Ordinary Meeting of Council

Wednesday 24 March 2021

**ATTACHMENTS TO REPORTS
ITEMS UNDER SEPARATE COVER**

6.1	Development Application No DA200109 - Erosion Gully Rehabilitation, 66 Brooklands Road, Wallaroo	
	Attachment B. Gully Rehabilitation Plan	3
7.1	Yass Water Treatment Plant Upgrade Project: Design and Business Case Preparation	
	Attachment A. Peer Review Report (Draft) on Impact of Stage 1 Works.....	43

Figure 4-1 Turbidity fluctuations over July 2012-December 2020 period

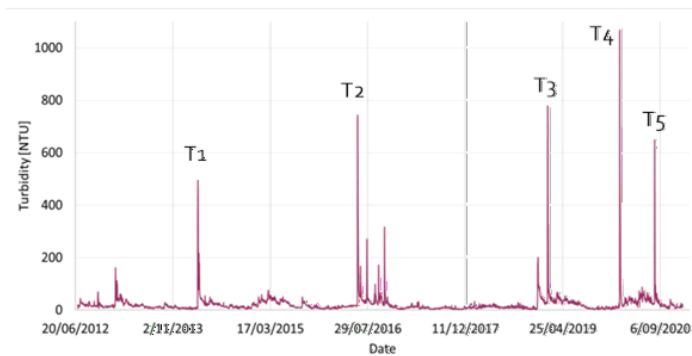
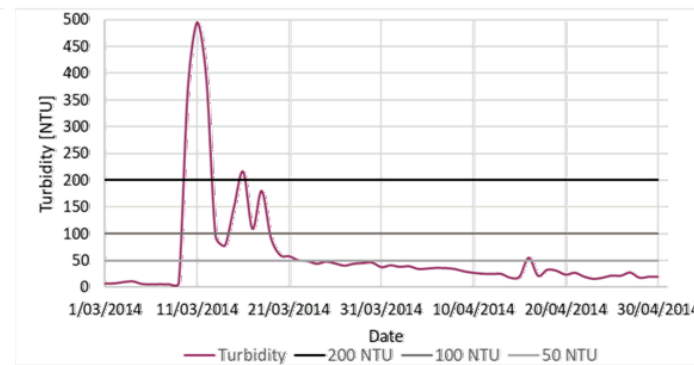
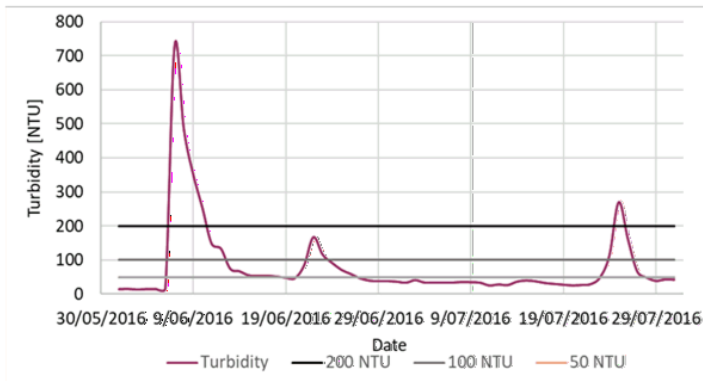
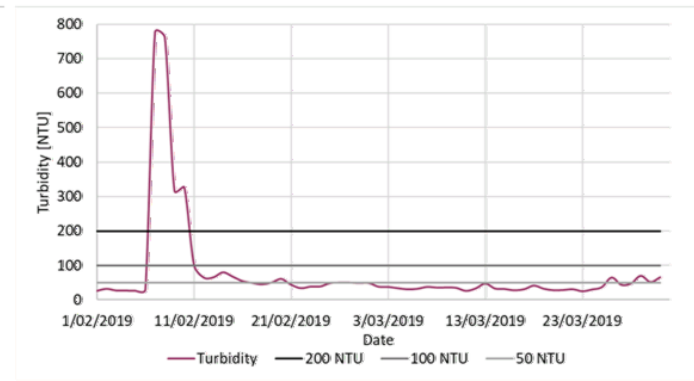
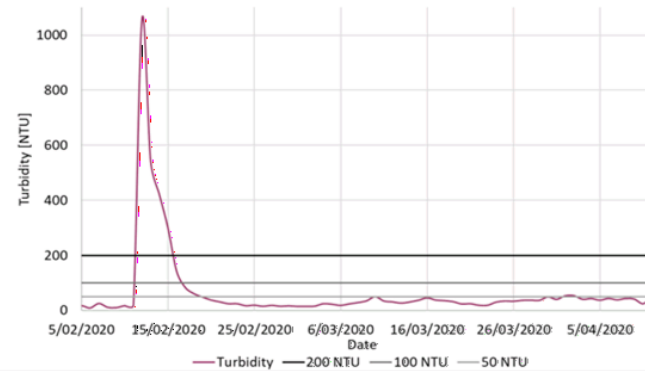
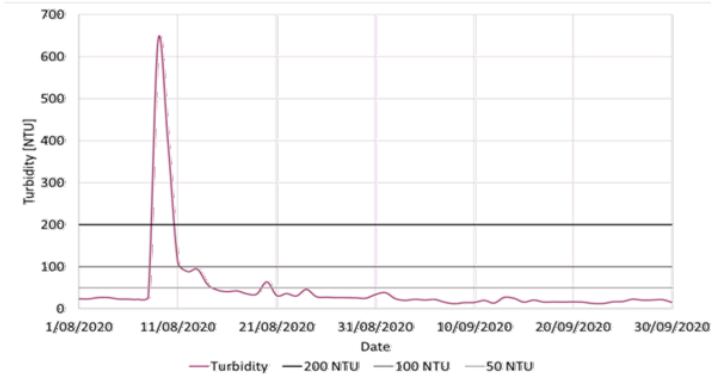
In addition to having limited treatment effectiveness at or above the design capacity of 100 NTU, WTP performance is further impacted when these conditions persist for extended periods or reoccur within weeks. The maximum turbidity that a WTP utilising a DAF clarification process followed by single media filtration could treat is anecdotally in the order of 200 NTU, with an influent turbidity of <50 NTU being preferred for optimum DAF performance. To successfully treat water with high turbidity, the WTP in its current state would need to be downrated significantly to increase air/water interface for effective flotation.

The graphs below illustrate the gradual reduction in turbidity after each of the five rainfall events analysed.

The existing WTP has a maximum filtered water turbidity target of 1 NTU, which is only just acceptable for potable water as the ADWGs state that disinfection is compromised above 1 NTU. The existing plant does not meet the current ADWGs which require a filtered water target of 0.2 NTU and not to exceed 0.5 NTU.

Figure 5-1 Additional equipment and space required for pre-treatment clarification

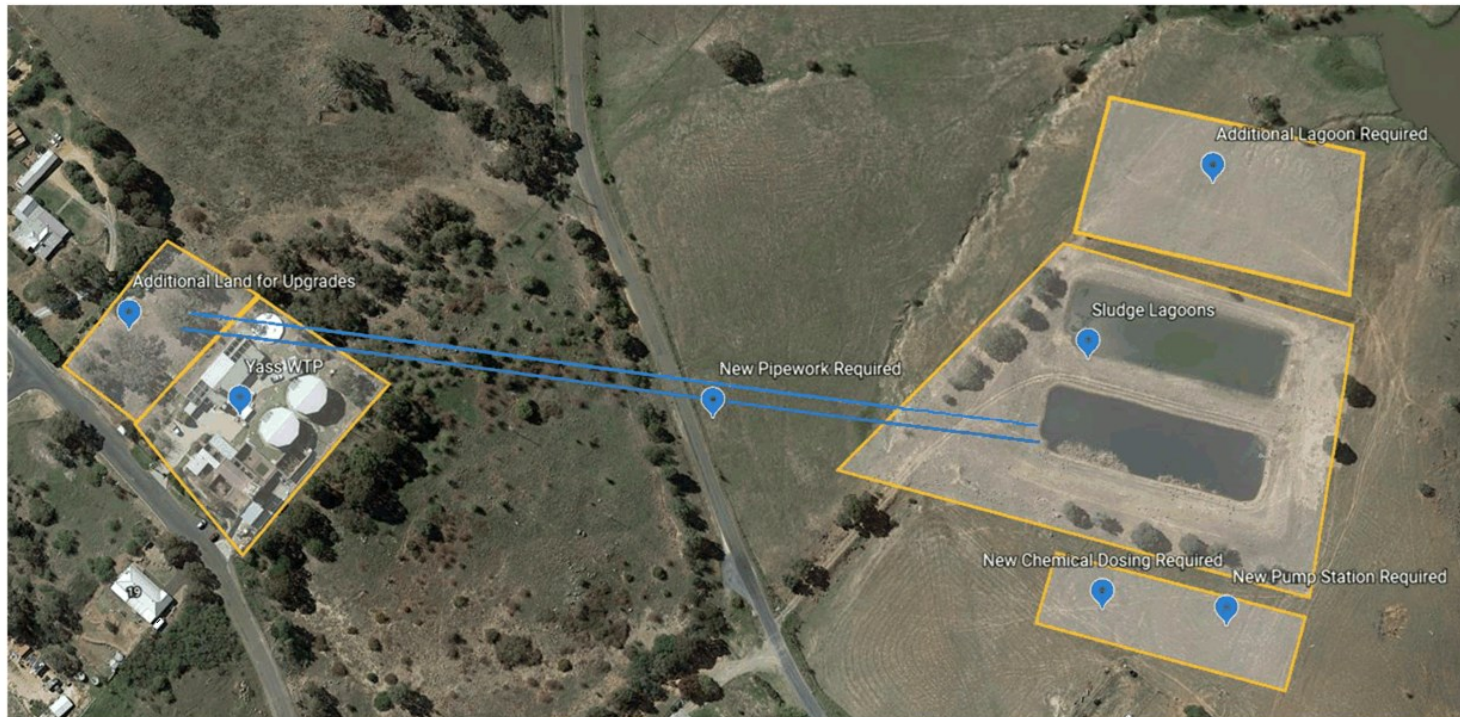
A visual representation of these upgrades is shown in Figure 5-1. The space required for additional pump stations, pipework, sludge lagoons, and chemical dosing systems is not available at the existing WTP site and would require procurement of additional land.

CWT does not recommend moving forward with consideration of this option as it has logistic, operational, and treated water quality issues.

CWT recommends that the implementation of Stage 1 be completed as proposed, but with the following modifications:

- ▲ Installation of an oxidation tank following potassium permanganate dosing to provide at least 15 minutes effective contact prior to coagulation/flocculation;
- ▲ Installation of a PAC contact tank would also have a significant impact on WTP performance under poor raw water quality conditions. The oxidation and PAC contact tanks could be combined and/ or additional raw water storage added. This tank could also receive recycled wastewater if required in the future; and
- ▲ Online manganese monitoring and chlorine residual monitoring.
